Access Compliance Report

Public Rights-of-Way

Intersection ID: 5855	Main Street: W_SUGAR_CREEK_RD	Cross Street: NEVIN_RD	Location:	N
ADA ID: 6E60D2437164	Ramp Type: BlendTrans1	Initial Pass/Fail: Pass	Overall Compliance: No	Severity Score: 15

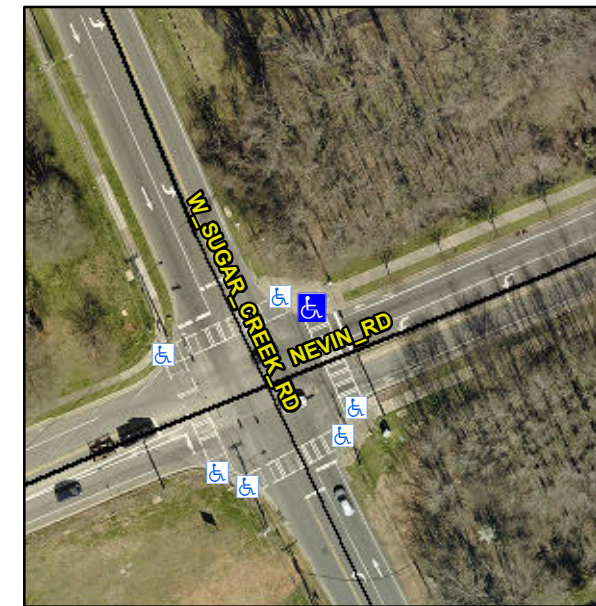
Not Found, R305.2, R302.7, R302.7.2

Yes	Ramp inside XWalk1?	Yes	N/A	Ramp inside XWalk2?	N/A
	Road Slope (%)	1.3		Clear Space?	Yes
	Road X Slope (%)	2.6	N/A	Clear Space to XWalk (in)	N/A
Yes	Any Obstructions?	No	Yes	Storm Grate/Utility Hazard?	No
	Obstruction Type			Storm Grate/Utility Type	
			N/A		N/A
			Yes	Surface Condition? (G/P)	Good
			No	Curb Slope (%)	25.6

Remove & Replace Curb Ramp With Two New Directional Ramps or Equivalent.
